May 11, 2015

SUBJECT: Contract 008066
SR 520, Floating Bridge and Landings Project
Federal Aid No. BR-0520(047)
Change Order No. 191 – November 13, 2014 Project Resolution

Attached for Headquarters Construction execution and further processing is Project Office recommended Change Order No. 191 – November 13, 2014 Project Resolution.

Begin omission of 42" single slope barrier

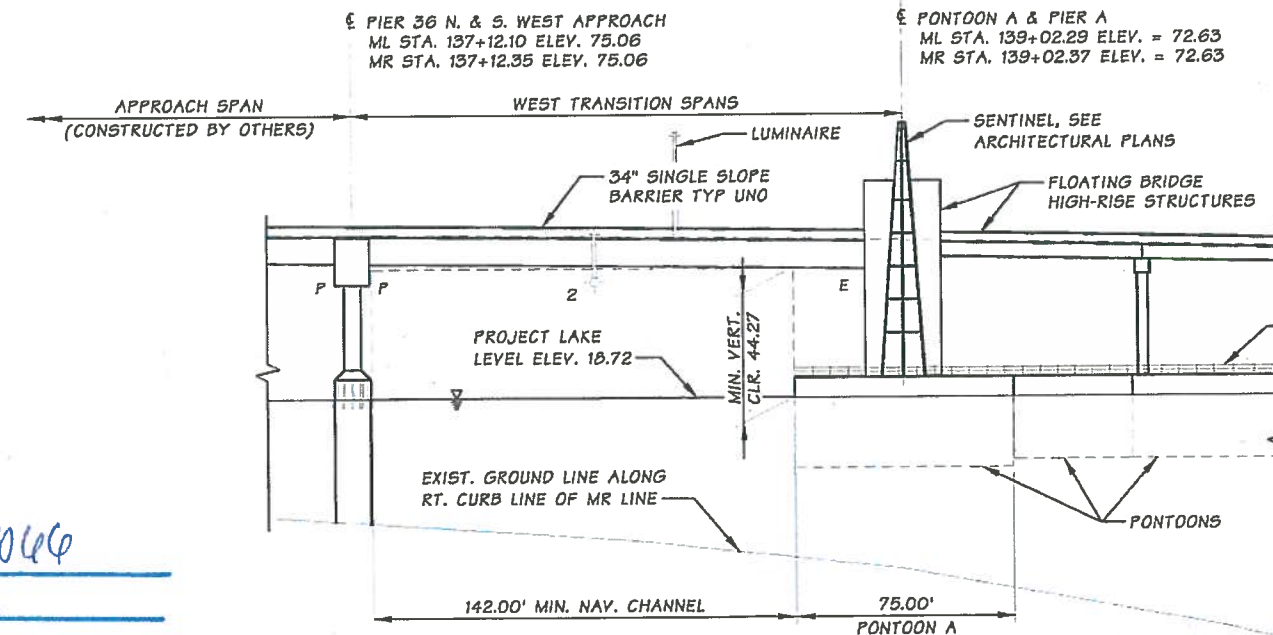
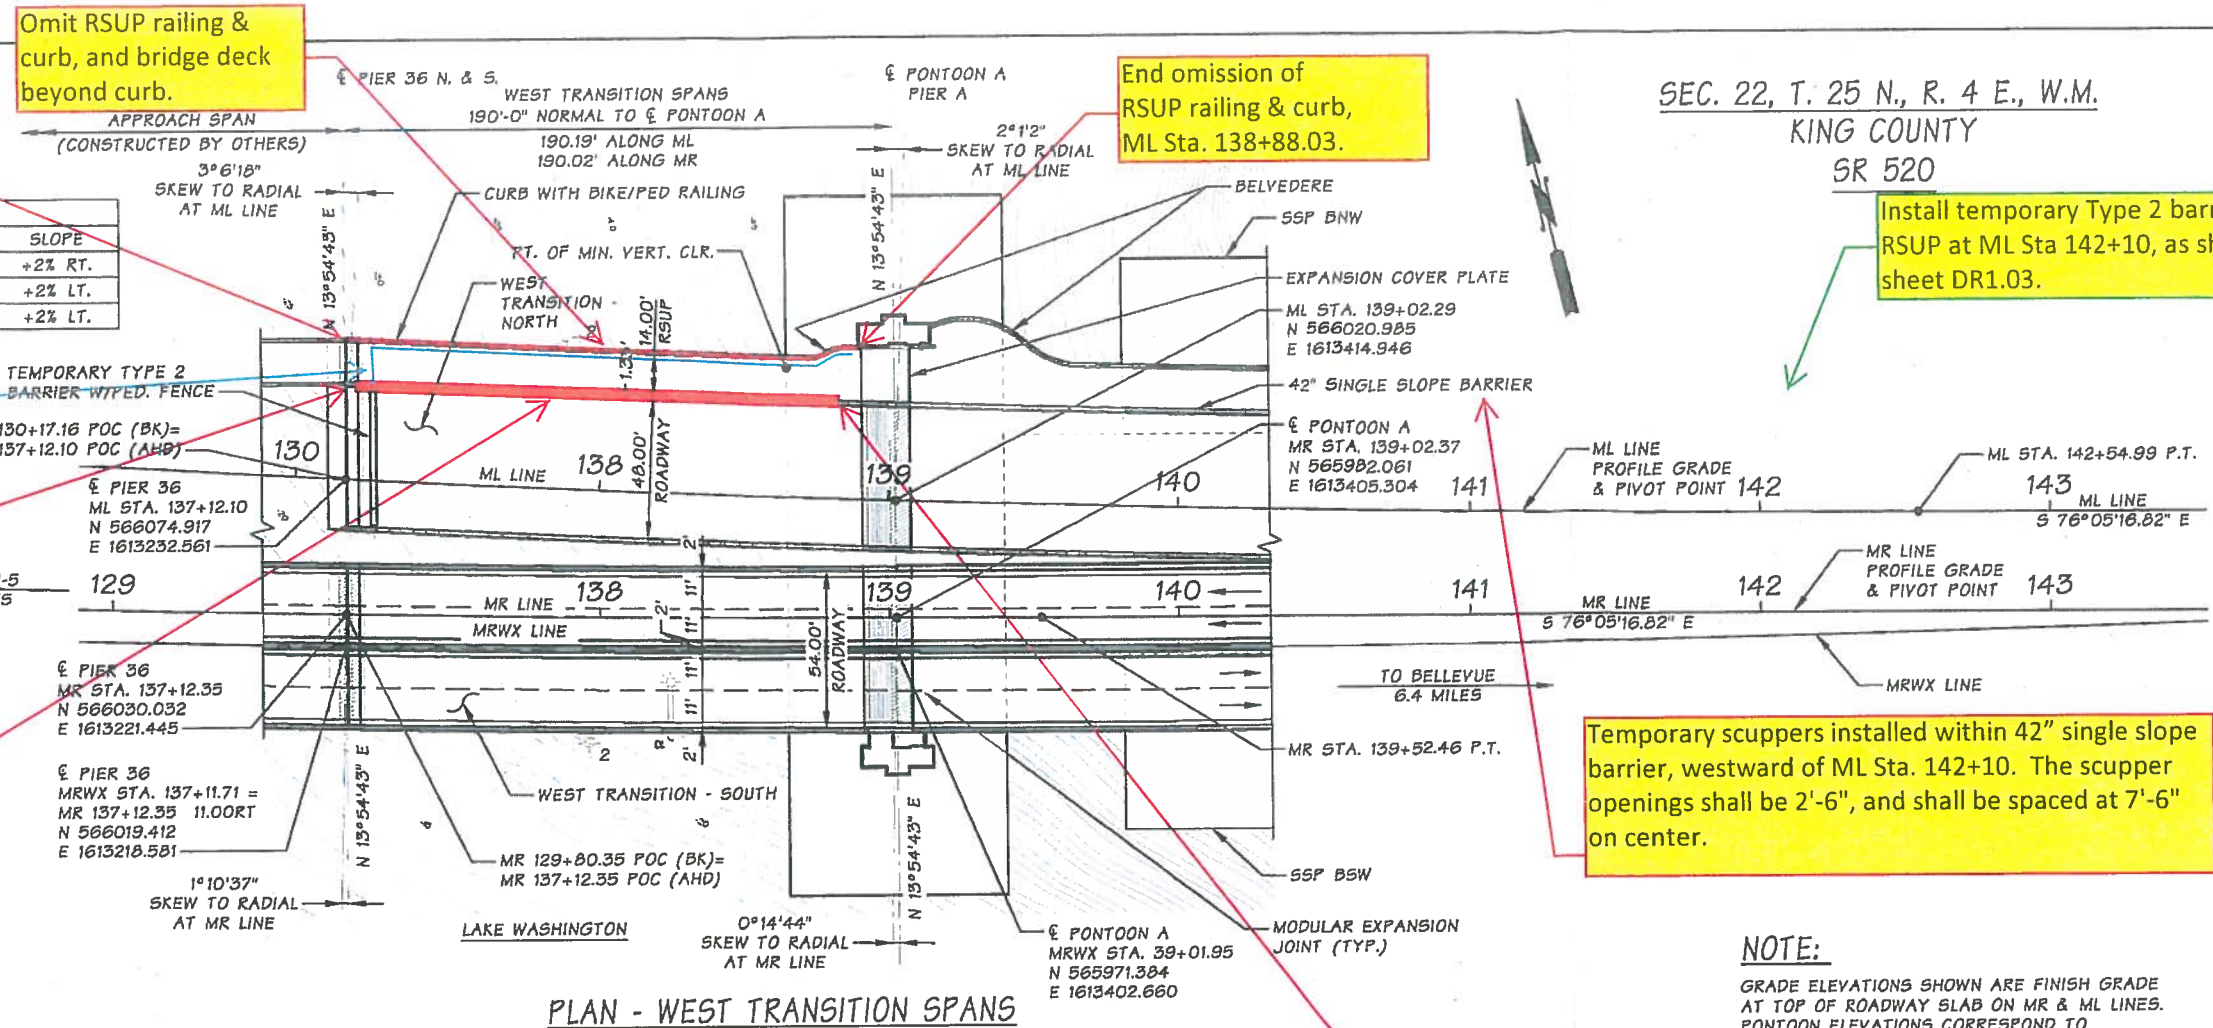
Install temporary Type 2 barrier on RSUP at ML Sta 142+10, as shown sheet DR1.03.

Omit 42" single slope barrier, install rebar mechanical couplers, provide roughened construction joint.

Temporary scuppers installed within 42" single slope barrier, westward of ML Sta. 142+10. The scupper openings shall be 2'-6", and shall be spaced at 7'-6" on center.

ML STA. 137+22.48
(47.33' LT)

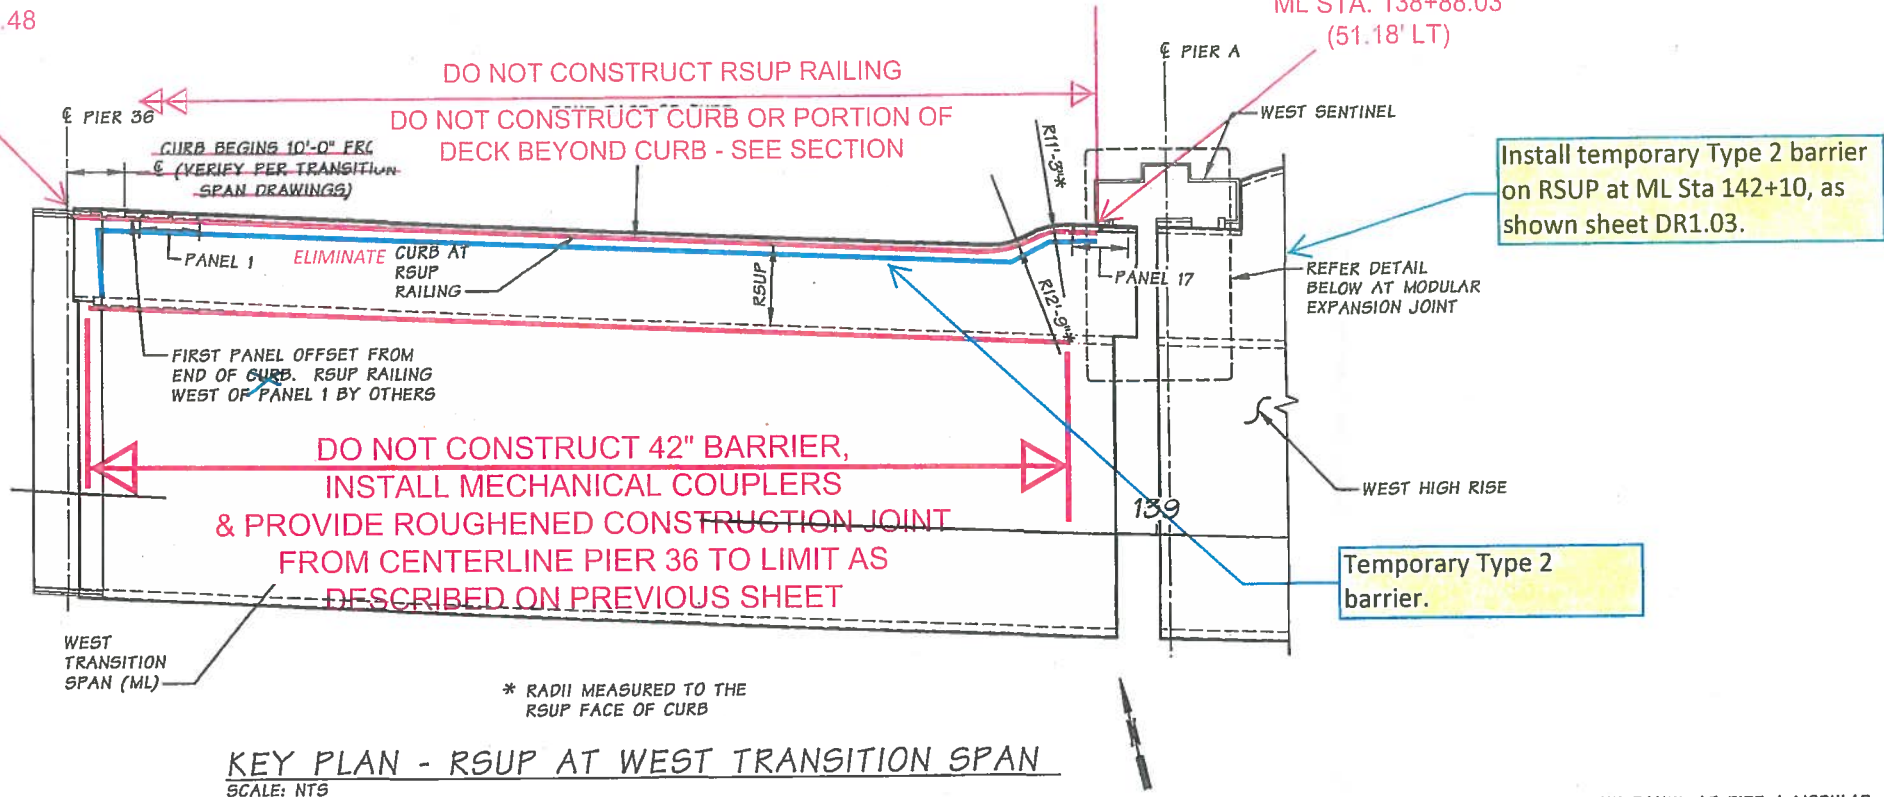
Install temporary Type 2 barrier on RSUP at ML Sta 142+10, as shown sheet DR1.03.

STANDARD RSUP RAILING & CURB, WITHIN BOXED AREA, NOT TO BE CONSTRUCTED

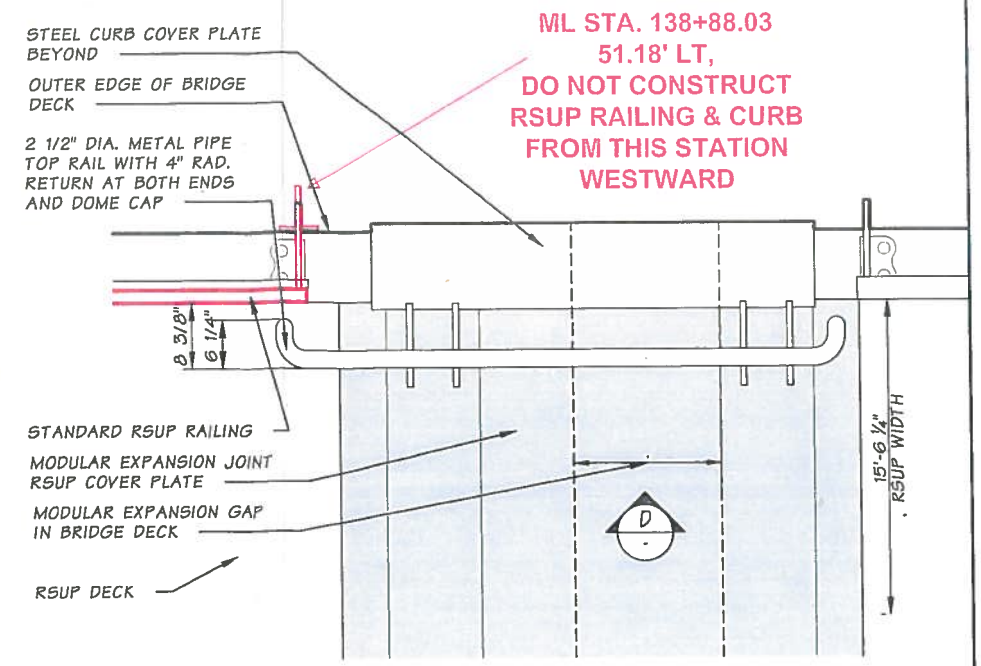
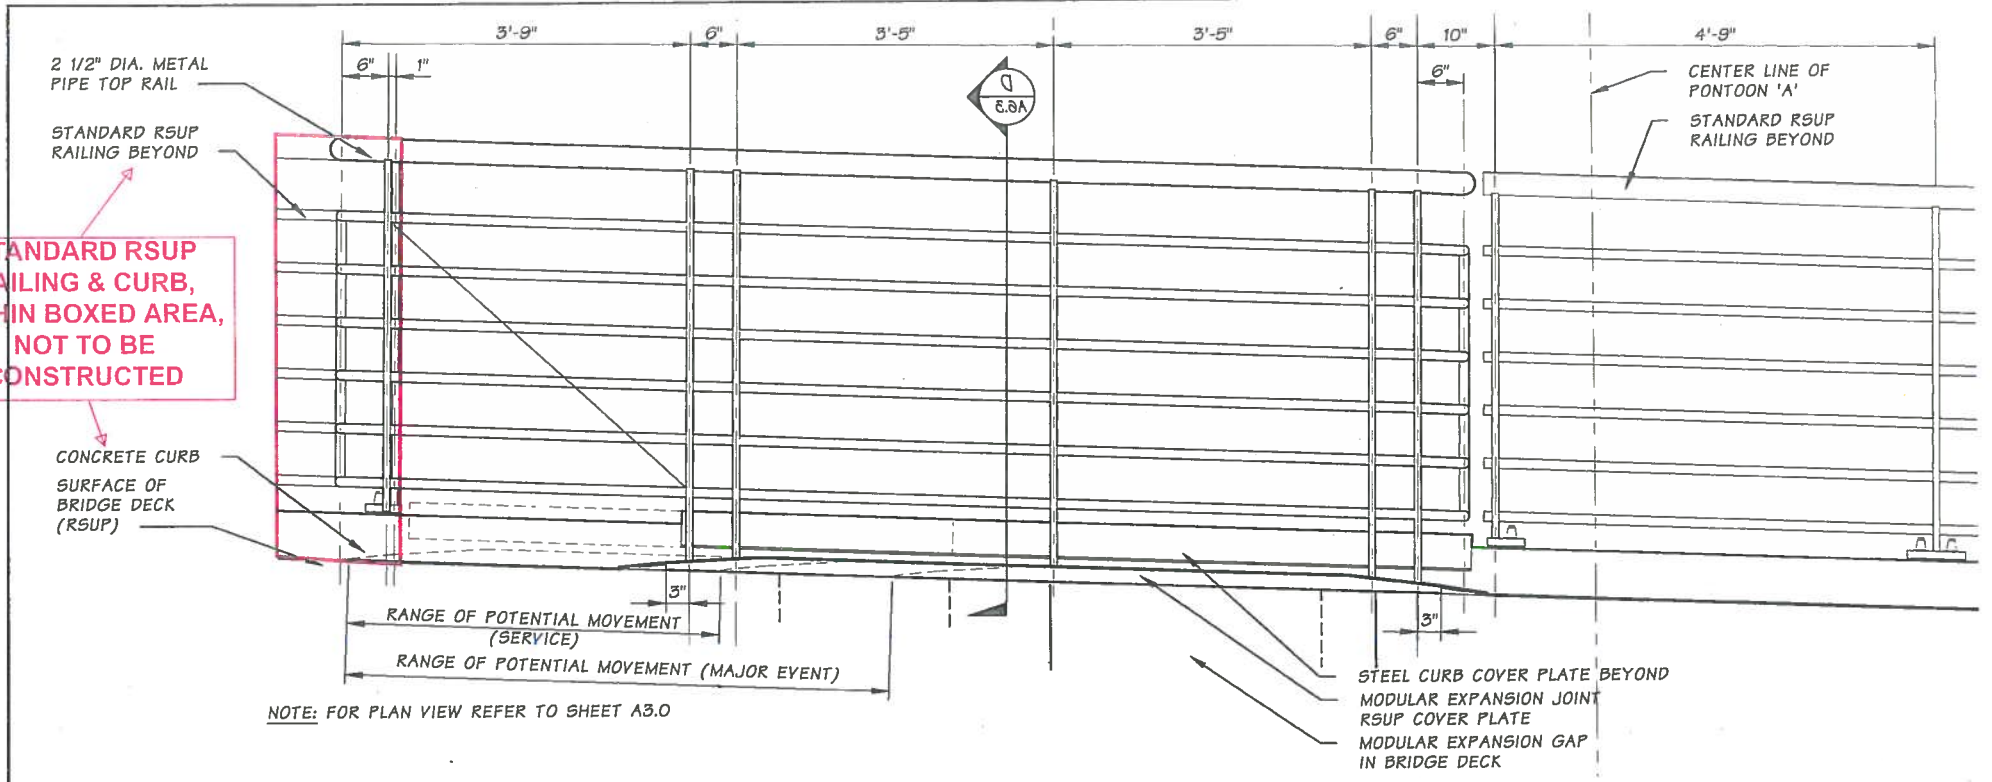
**ML STA. 138+88.03
51.18' LT,
DO NOT CONSTRUCT
RSUP RAILING & CURB
FROM THIS STATION
WESTWARD**

SECTION - WEST TRANSITION SPAN - NORTH
LOOKING AHEAD ON STATION

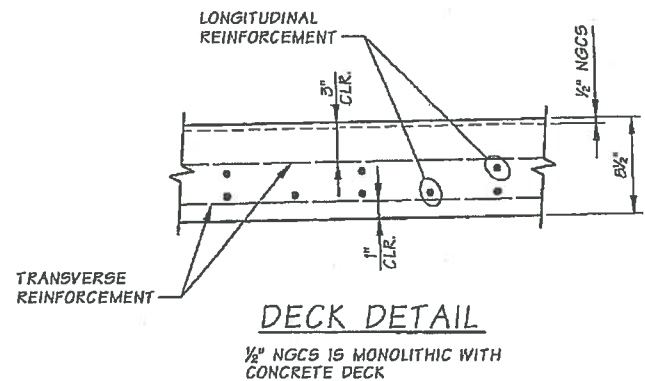
Install 2-inch conduit stub outs through the bottom of the roadway deck. RFP Section 2.13.4.22 addresses stub out requirements.

Install temporary Type 2 barrier, in lieu of RSUP railing & curb. Barrier shall be Precast Concrete Barrier Type 2 with Scuppers.

Do not construct the curb and the portion of bridge deck beyond the curb. Station limits same as for omission of RSUP railing.

Do not construct traffic barrier, install mechanical couplers & provide roughened construction joint, from centerline of Pier 36 eastward to limit determined by KGM.
